STAFF RECOMMENDATION
118 Lauderdale Road
December 21, 2016

Application: New construction—addition and Detached Accessory Dwelling Unit; Setback determination.
District: Cherokee Park Neighborhood Conservation Zoning Overlay
Council District: 24
Map and Parcel Number: 10312021800
Applicant: Tyler LeMarinel, Allard Ward Architects
Project Lead: Melissa Baldock, melissa.baldock@nashville.gov

Description of Project: Application is to construct a rear and side addition, side dormer, and detached accessory dwelling unit. The application requires a rear and side setback determination for the DADU. **Recommendation Summary:** Staff recommends approval of the project with the following conditions: 1. The applicant submit drawings with all the major measurements labeled and the new construction clearly differentiated from the historic house; 2. Staff receive a copy of the filed restrictive covenant; 3. The window opening on the Valley Road façade remain, and be closed up on the interior if necessary; 4. Staff approve a brick sample; 5. Staff approve the roof color and materials; 6. Staff approve all windows and doors prior to purchase and installation; 7. The HVAC shall be located behind t

Figure 4. Shows the existing double-wide curb cut.

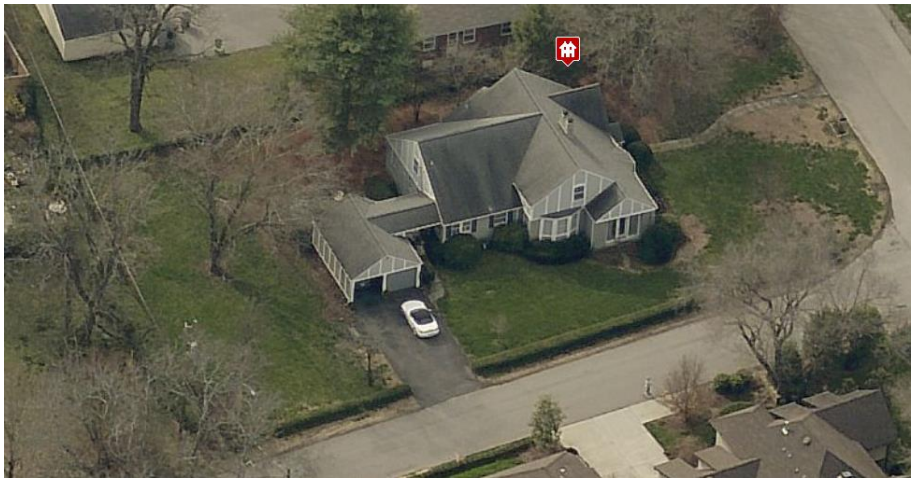
**The applicant intends to create a new double-wide curb cut at the rear of the lot, off of Valley Road. There is an existing double-wide curb cut in the middle of the lot, off of Valley (Figure 4). Staff recommends that the existing double wide curb cut be removed prior to the construction of the DADU.

With the condition that the existing curb cut be removed, staff finds that the DADU meets section II.h.2 of the design guidelines and 17.16.30.G. 4 of the ordinance.

1 Site Plan

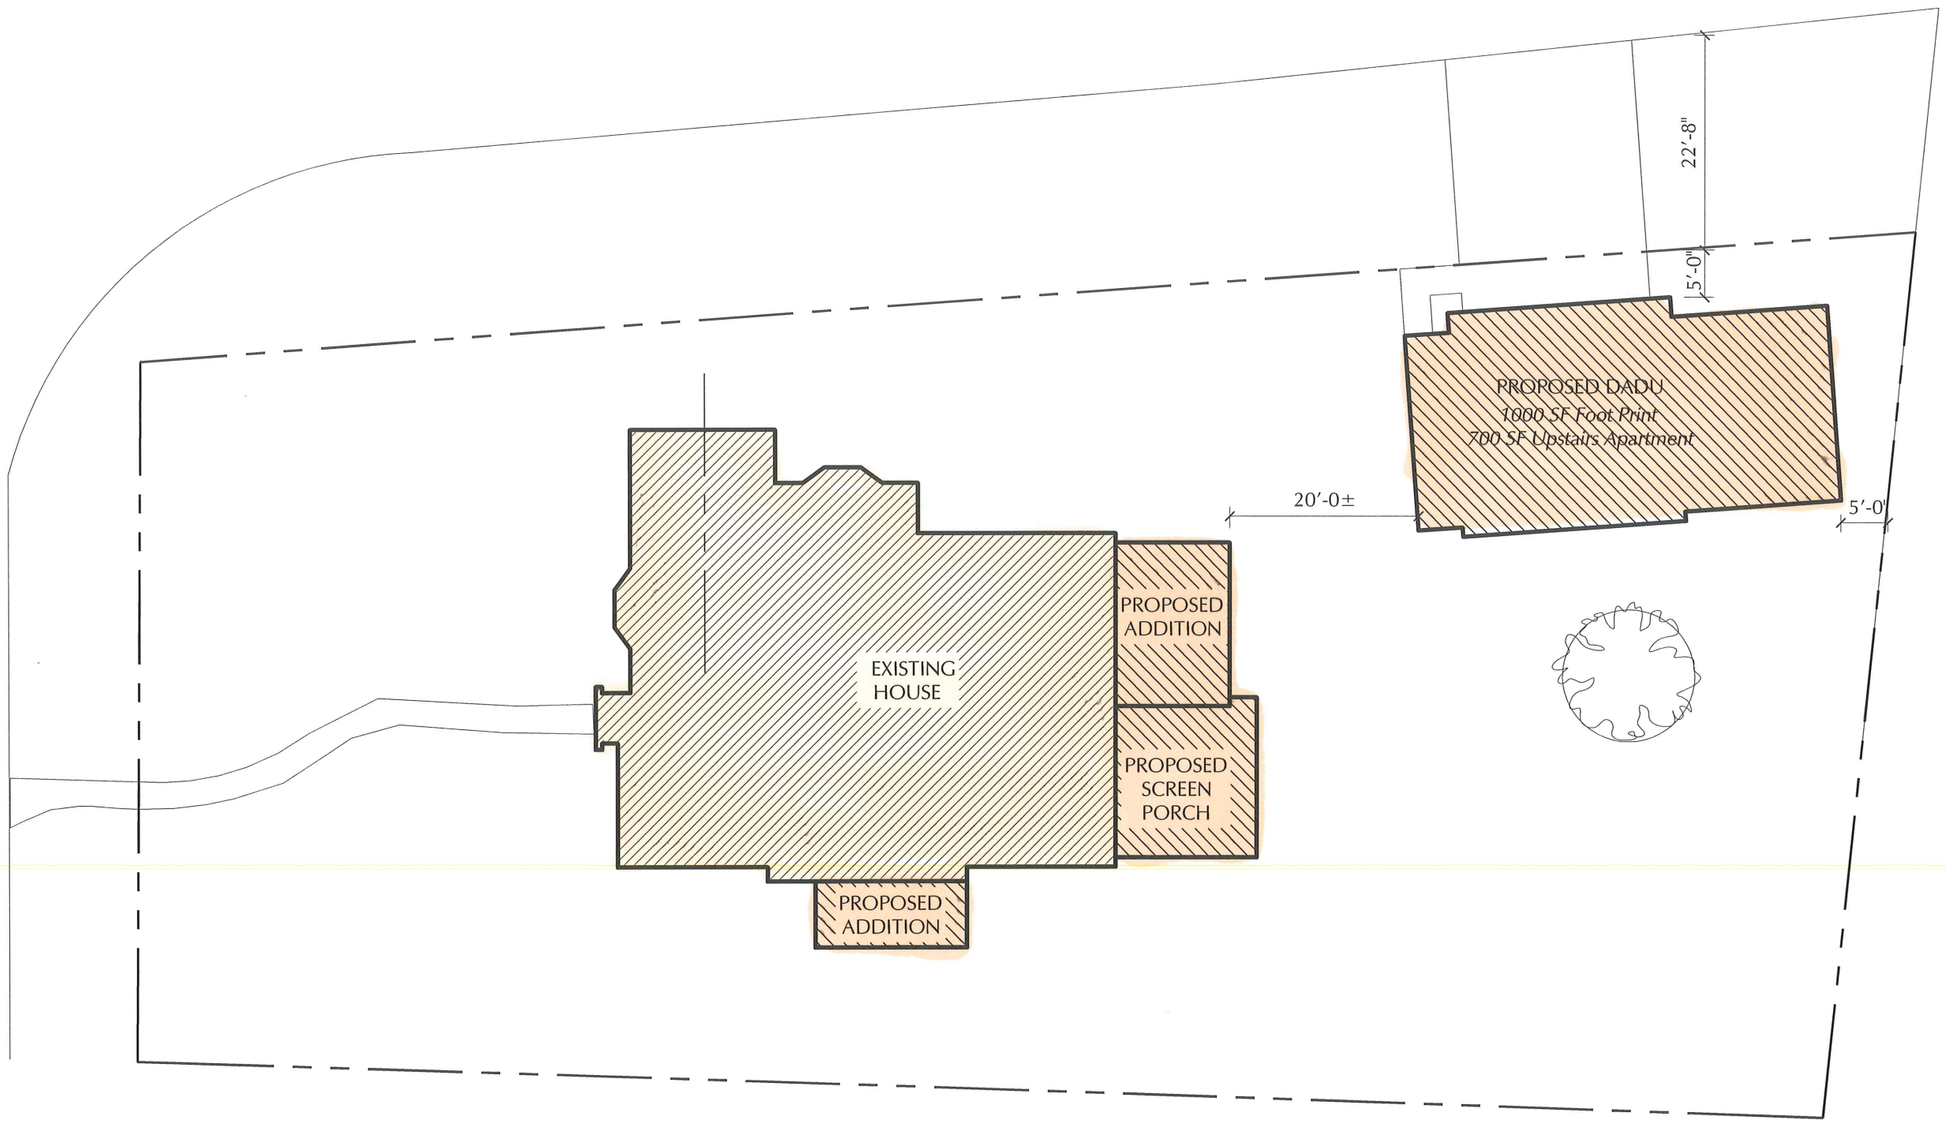
MINIMUM	PROPOSED
Space between principal building and DADU/Garage	20’	20’
Rear setback	20’	5’*
L (Valley Road) side setback	3’	5’*
R side setback	5’	Over 60’
How is the building accessed?	From the alley or existing curb cut	New Curb Cut**

*The DADU requires a change to both the rear and the Valley Road side setbacks. Base zoning requires a twenty foot (20’) rear setback when outbuildings are larger than seven hundred square feet (700 sq. ft.). The proposed DADU is one thousand square feet (1000 sq. ft.), and the applicant is proposing to locate it just five feet (5’) from the rear property line. Staff finds the proposed rear setback to be appropriate because outbuildings historically were located near or on the rear property line. A five foot (5’) rear setback is more historically appropriate than a twenty foot (20’) rear setback. In addition, the five foot (5’) rear setback allows for more space between the primary structure and the DADU.

Base zoning requires a twenty foot (20’) side setback when there is an outbuilding with garage doors that face a side street. The applicant is proposing to situate the outbuilding just five feet (5’) from the side property line. However, in this instance, there is a large, twenty-two foot, eight inch (22’8”) right of way that is currently being used as part of the yard for 118 Lauderdale Road. This will give the appearance of a larger side setback and means that the structure will be more than twenty feet (20’) from the roadbed. In addition, there are no other houses that face Valley Road on this side of the street, so there is not an established Valley Road setback for the DADU to meet. The five foot (5’) setback allows for the retention of a tree.
